<< Editor's Note: This text describes changes to Clause 41 required to add the VDP notification TLV discussed in the May 2011 Interim meeting. A Status octet of the VDP notification TLV contains a bit indicating whether the VM associated with the VSI is started or stopped. The notification is sent by the EVB Station to the EVB Bridge when the status changes. The changes made to the clause for this purposes are:

## **41. VSI discovery and configuration protocol (VDP)**

### 41.3 VDP notification TLV definition

**Figure 41-1—VDP notification TLV**

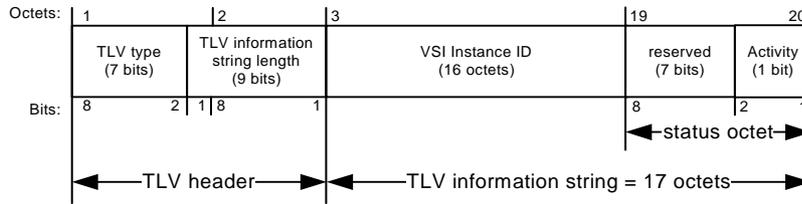
- 1) A third VDP TLV has been added to the lettered list of VDP TLVs specified in Clause 41.
- 2) A Notification TLV Type has been added to Table 41-1.
- 3) Subclause 41.3 has been added to describe the VDP notification TLV.

Figure 41-1 illustrates the format of the VDP notification TLV. The VDP notification TLV field definitions

are specified within subclauses 41.3.1 through 41.3.4. A VDP notification TLV is sent by the EVB Station when one of the following conditions is met:

- 1) the user of a VSI Instance becomes active (e.g., the associated VM has started) and the user of that VSI Instance has previously been active when the VSI Instance was associated with a different SBP (e.g., the associated VM has migrated).
- 2) the user of a VSI Instance becomes inactive (e.g., the associated VM has stopped) and the user of that VSI Instance will become active again after VSI Instance is associated with a different SBP (e.g., the associated VM is being migrated);
